**Amendment and Response**

Serial No.: 10/668,851

Title: PHASE DIGITIZER FOR SIGNALS IN IMPERFECT QUADRATURE

**Fig. 4**

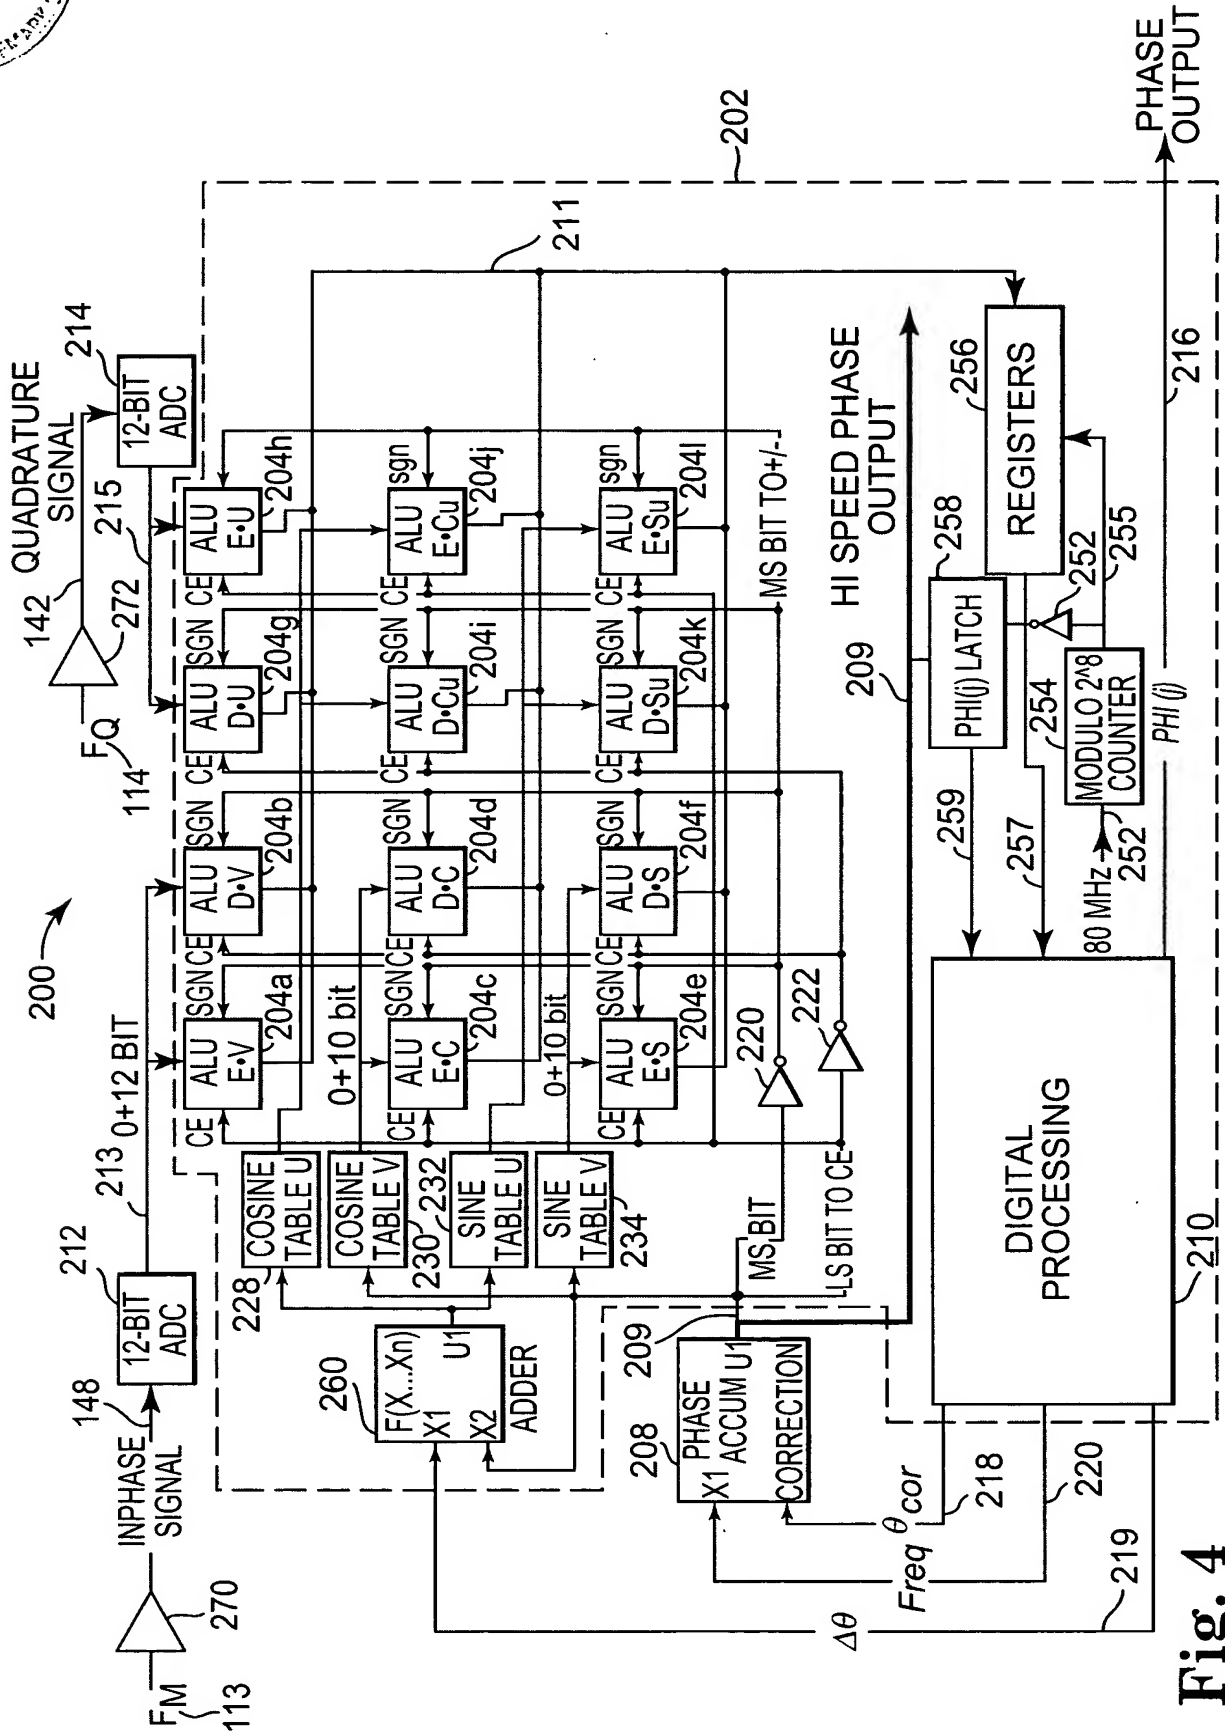
Figure 4 is objected to because it does not agree with the Specification. Figure 4 has been amended to clearly show that the other input of adder 260 is electrically coupled to the output of circuit 208 through path 209. Therefore, withdrawal of the objection to Figure 4 is respectfully requested.

Figure 4 has been amended as indicated in red in the attached annotated sheet showing changes. In addition, a replacement sheet incorporating the amendment to Figure 4 is also attached.
